The Commission has issued the enclosed Amendments Nos. 44, 40 and 17 to Facility Licenses Nos. DPR-33, DPR-52 and DPR-68 for the Browns Ferry Nuclear Plant, Units Nos. 1, 2 and 3. These amendments consist of changes to the Technical Specifications in response to your requests of August 2, 1978 (BFNP TS 112) and August 11, 1978 (BFNP TS 114).

AMENDMENT TO FACILITY OPERATING LICENSE

Amendment No. 44  
License No. DPR-33

ATTACHMENT TO LICENSE AMENDMENT NO. 44

Figure 4.2-1

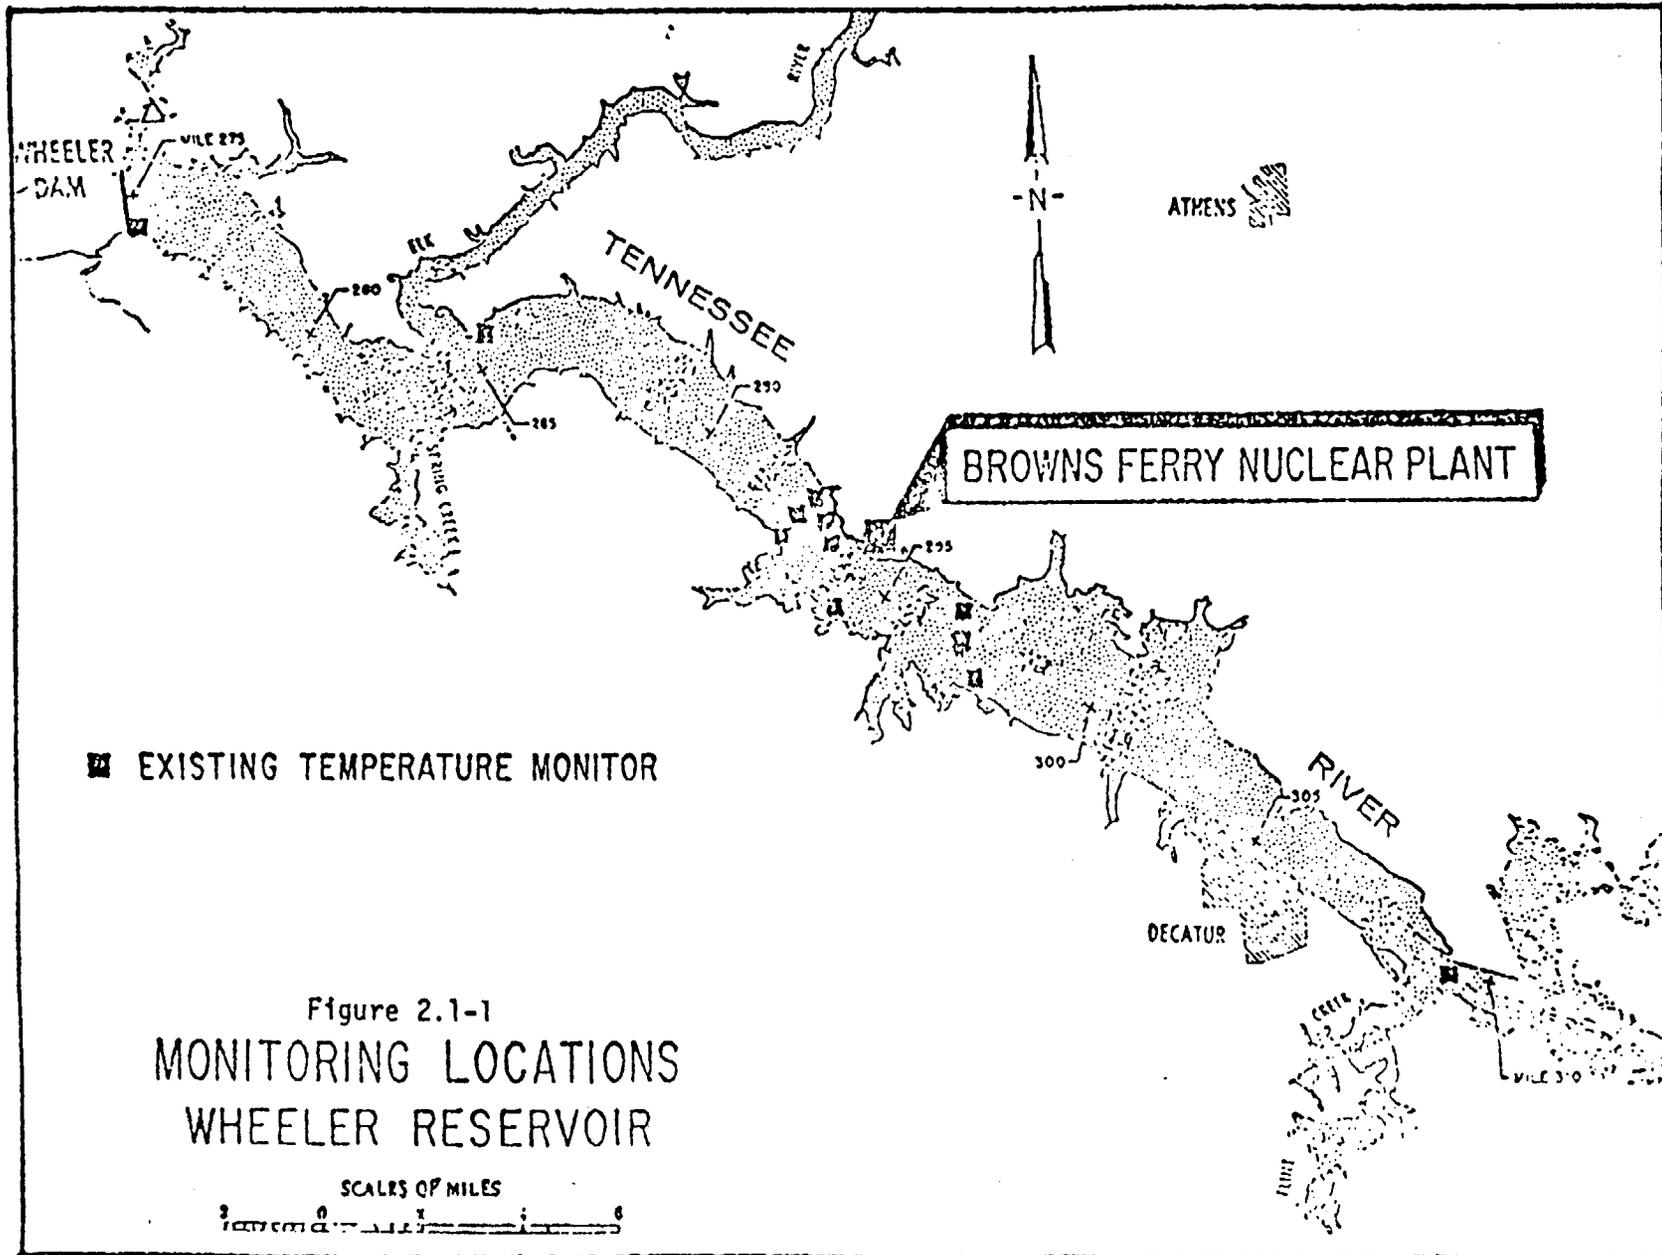
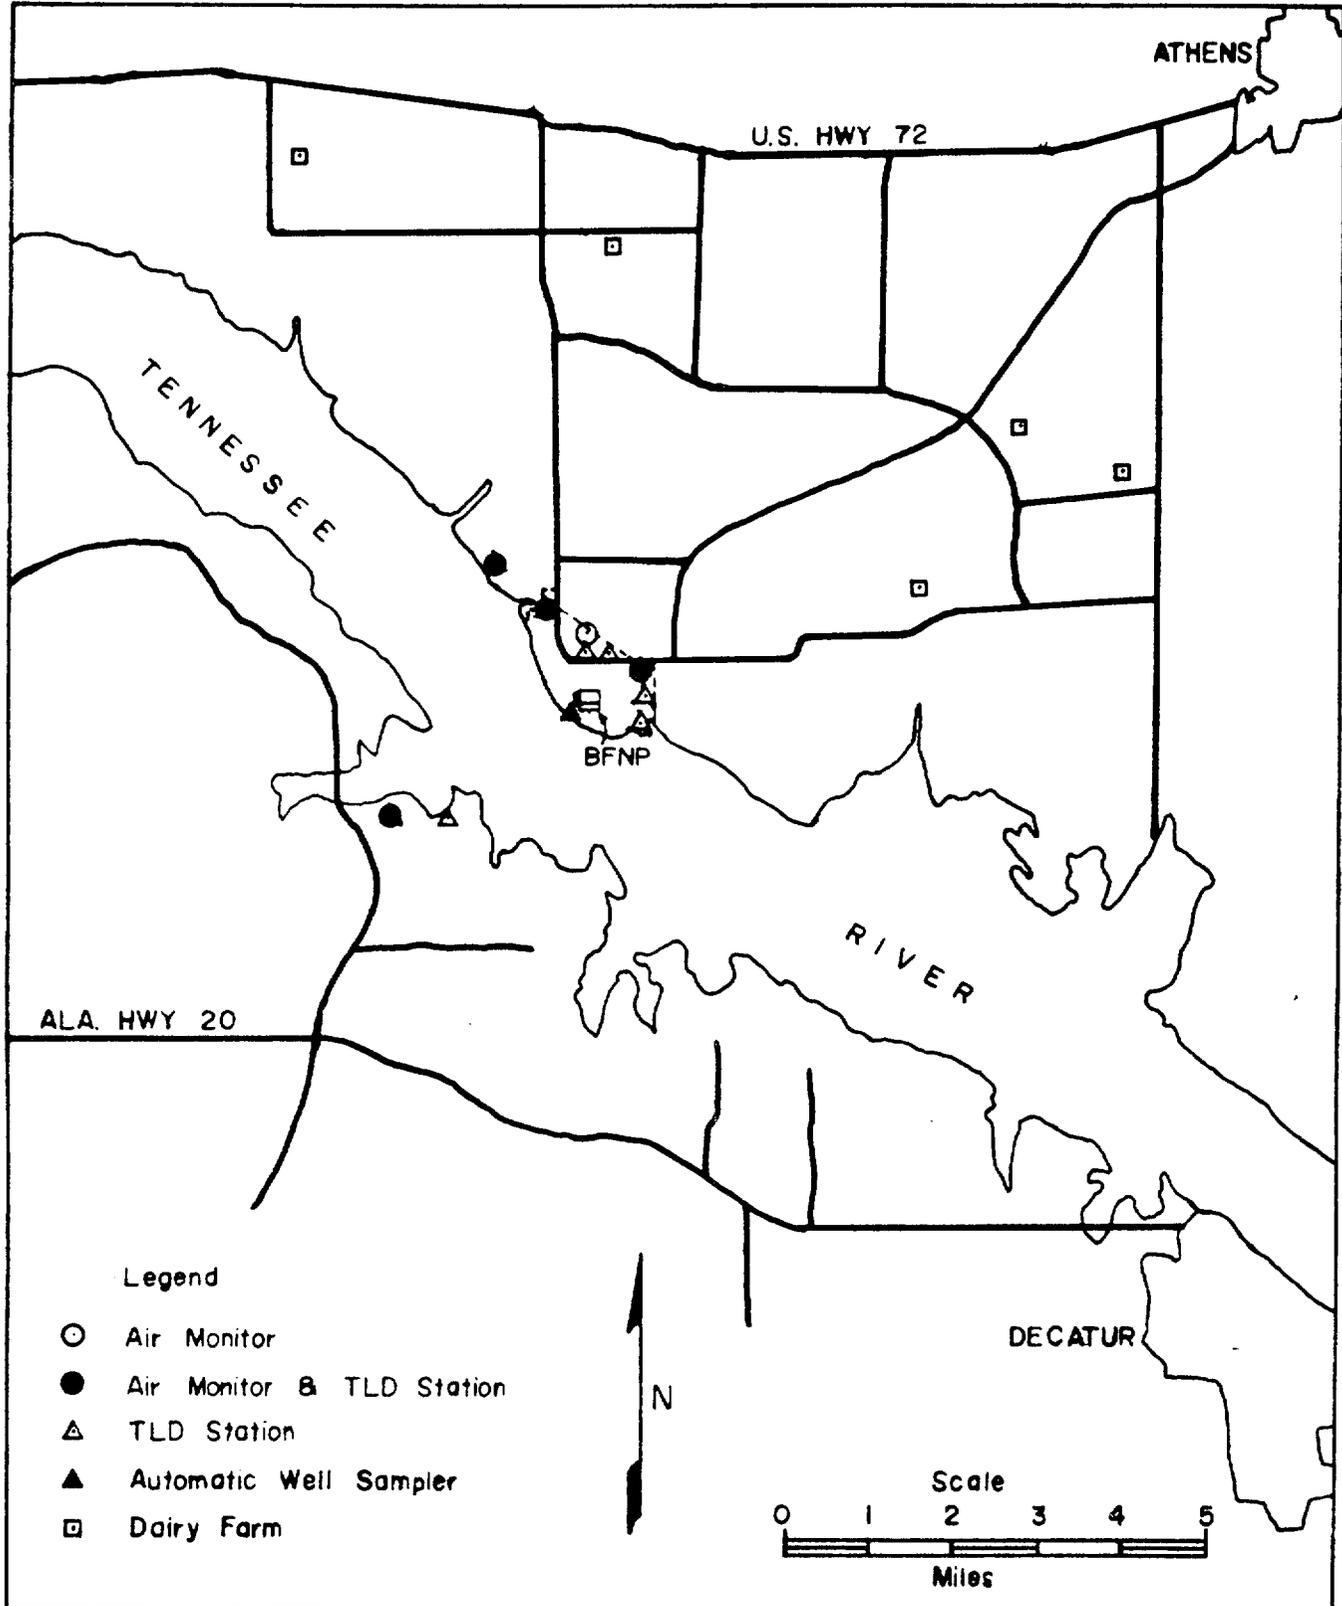
As part of the environmental radiological monitoring program at the Browns Ferry Nuclear Plant, TVA collects and analyzes a number of samples. The Browns Ferry Nuclear Plant Environmental Technical Specifications state that "milk shall be collected....from at least four farms in the vicinity of the plant..." and that "...any location from which milk can no longer be obtained may be dropped from the surveillance program. The NRC shall be notified in writing that milk-producing animals are no longer present at that location. An additional milk sampling location will then be added to the program..." (Section 4.2.3.b).

As of May 15, 1978, milk is no longer available from the dairy farm located approximately four miles north of Browns Ferry Nuclear Plant. The milk producing animals have been sold and removed from the farm. A dairy farm located approximately five miles north of the plant has been added to the monitoring program.

We have reviewed the meteorological data and deposition factors for the Browns Ferry plant and conclude that the new sample location is acceptable.
